| Revision | By | Date |
|--------------------------------|-----|----------|
| Addendum No. 1, Added Conduits | JRA | 07/17/17 |

RIVERCREST PROPOSED STADIUM
Mississippi County, Arkansas

ATHLETIC FIELD ELECTRICAL PLAN
Issued for Bidding

Sheet No.:
10
of
17

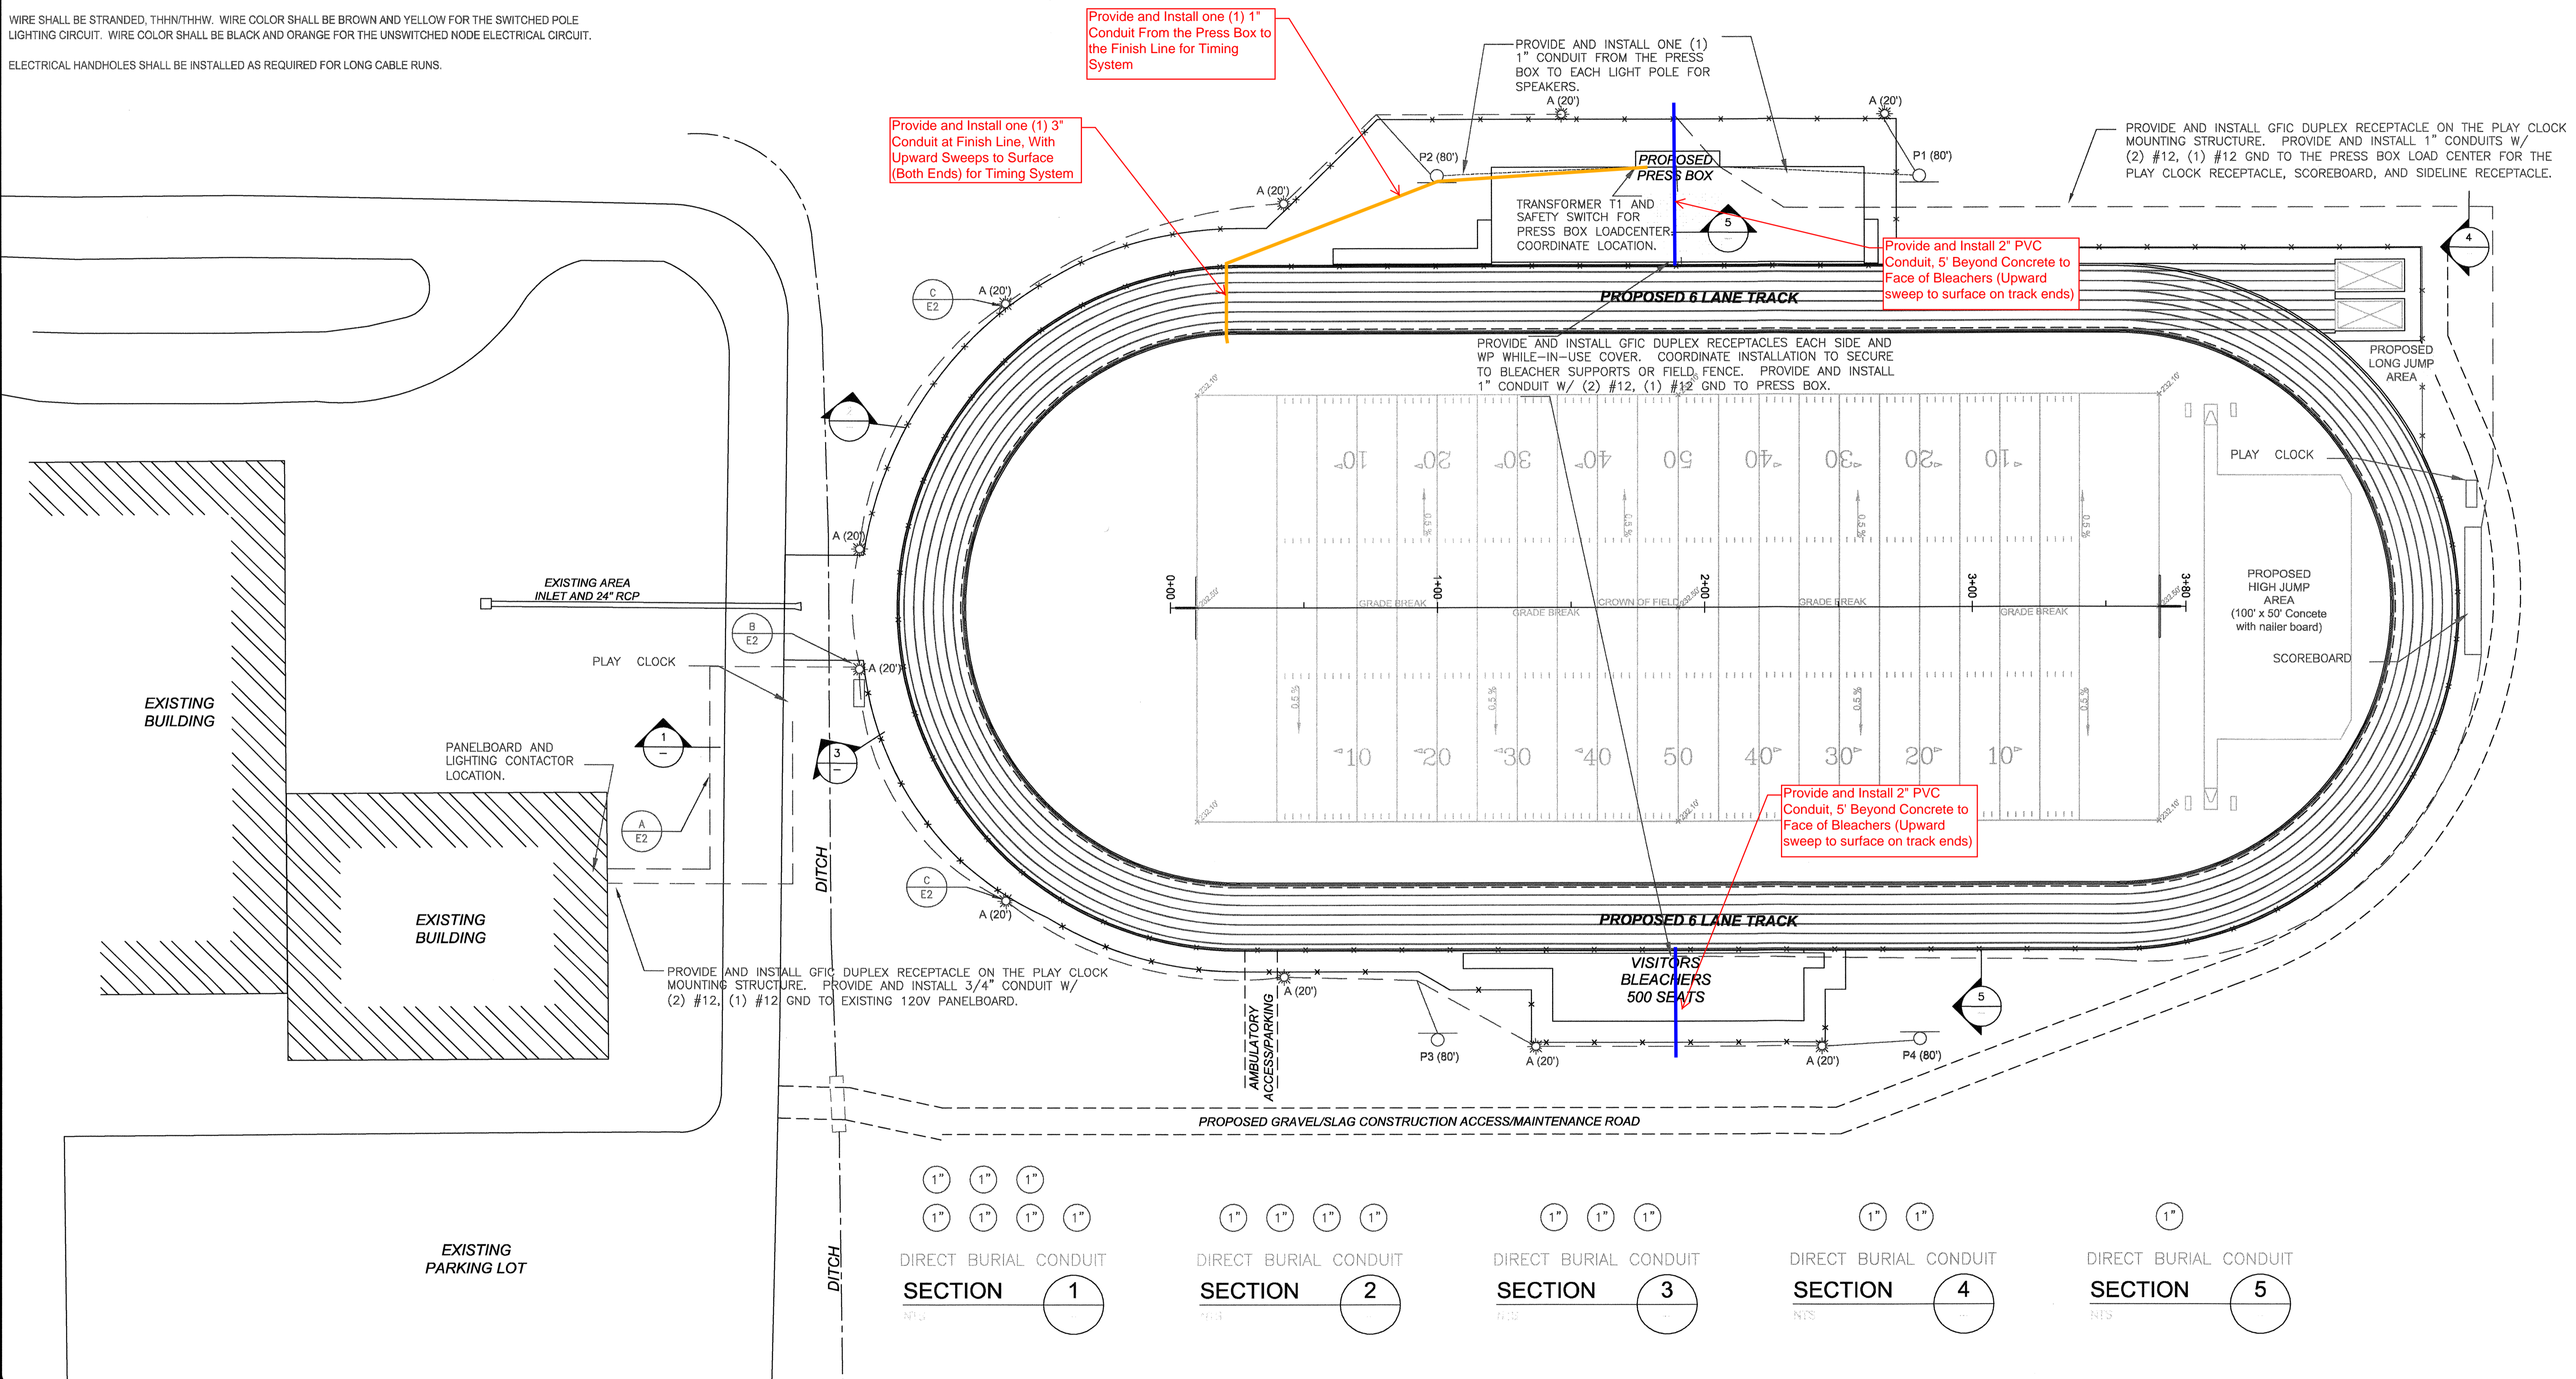
Provide and Install one (1) 1" Conduit From the Press Box to the Finish Line for Timing System

Provide and Install one (1) 3" Conduit at Finish Line, With Upward Sweeps to Surface (Both Ends) for Timing System

PROVIDE AND INSTALL ONE (1) 1" CONDUIT FROM THE PRESS BOX TO EACH LIGHT POLE FOR SPEAKERS.

Provide and Install 2" PVC Conduit, 5' Beyond Concrete to Face of Bleachers (Upward sweep to surface on track ends)

Provide and Install 2" PVC Conduit, 5' Beyond Concrete to Face of Bleachers (Upward sweep to surface on track ends)

PROVIDE AND INSTALL GFCI DUPLEX RECEPTACLE ON THE PLAY CLOCK MOUNTING STRUCTURE. PROVIDE AND INSTALL 1" CONDUITS W/ (2) #12, (1) #12 GND TO THE PRESS BOX LOAD CENTER FOR THE PLAY CLOCK RECEPTACLE, SCOREBOARD, AND SIDELINE RECEPTACLE.

PROVIDE AND INSTALL GFCI DUPLEX RECEPTACLES EACH SIDE AND WP WHILE-IN-USE COVER. COORDINATE INSTALLATION TO SECURE TO BLEACHER SUPPORTS OR FIELD FENCE. PROVIDE AND INSTALL 1" CONDUIT W/ (2) #12, (1) #12 GND TO PRESS BOX.

PROVIDE AND INSTALL GFCI DUPLEX RECEPTACLE ON THE PLAY CLOCK MOUNTING STRUCTURE. PROVIDE AND INSTALL 3/4" CONDUIT W/ (2) #12, (1) #12 GND TO EXISTING 120V PANELBOARD.
